STP MSPI FAQ – Estimates

Exelon FAQs

Millstone MSPI FAQs:

HOPE CREEK MSPI FAQs

Figure 1

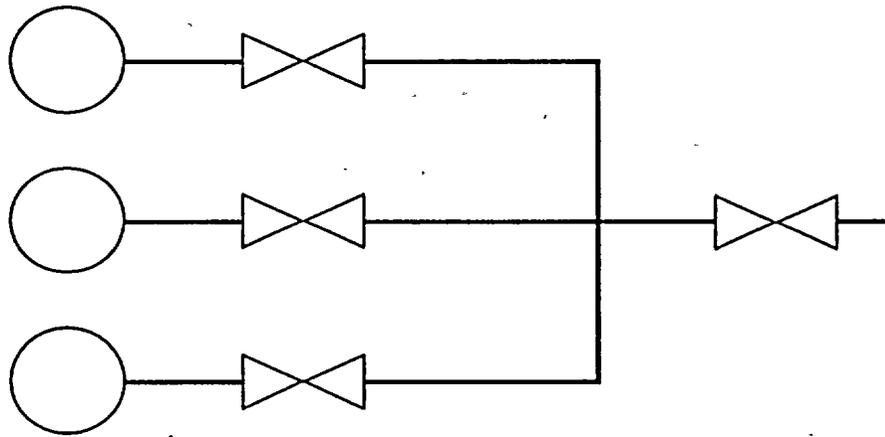
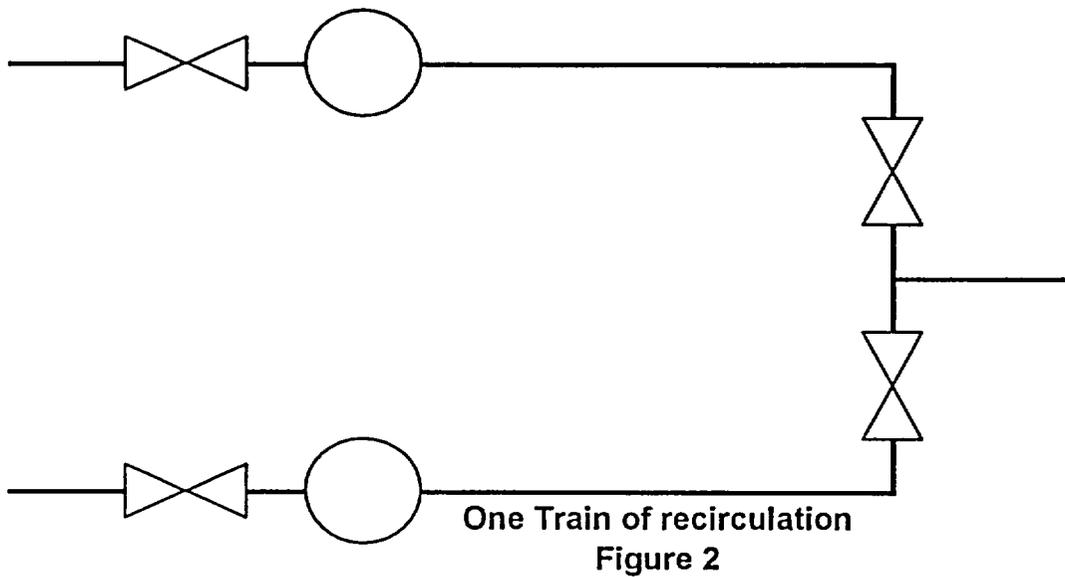
- a) MP3 has three charging pumps. Each pump has one MOV on its recirculation line. There is an additional MOV on the common line (Figure 1). The three branch lines are power off one train and the common line is powered off the opposite train. Therefore for each pump either the common MOV or the branch line MOV must go closed. If the branch line MOVs and the common MOV do not close, all trains are lost. Would these valves be considered active?

*what are system
screen criteria*

The charging minimum recirculation valves would be counted as active valves since they do not meet the redundancy criteria in that a failure of all valves impacts both trains. *The NRC staff concurs that this configuration is not a clear case of the straightforward parallel/series configuration discussed in Appendix F. As a first step, the valves in question here should be screened-in and included in the MSPI program. However, guidelines for excluding certain active valves based on low risk significance are being considered. If the FV/UR for any or all of these valves is lower than 0.1, and there is an overly burdensome number of valves that would otherwise be monitored (e.g. 20 or more total valves), then there is a justifiable basis for excluding some or all of these valves. The licensee should assess the FV/UR for these valves against the 0.1 FV/UR criterion, and consider alternatives.*

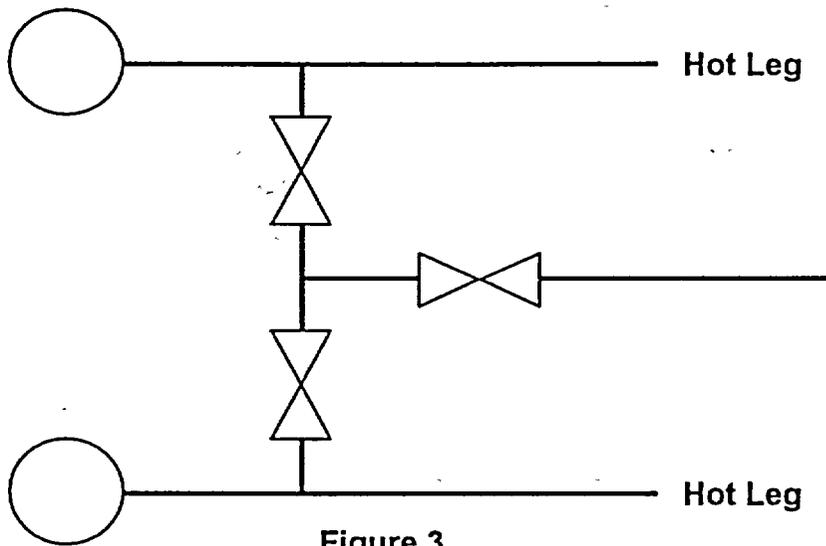
- b) For recirculation MP3 has a two train system. Each train consists of two pump trains, of which one pumping train is required for recirculation (Figure 2). The pumping train consists of a suction MOV from the sump, a pump, and a discharge MOV to a common line which provides suction to either the intermediate head pumps or charging pumps. Each pumping train has its own discharge valves to the common header and can not be

cross-connected. Since only one pumping train is required, are the suction and discharge valves considered active?

Yes since the pumping trains can not be cross tied. *The NRC staff concurs. However, as with the case discussed in Question 5a above, the licensee could assess alternatives based on the FV/UR criterion for the valves in question here.*
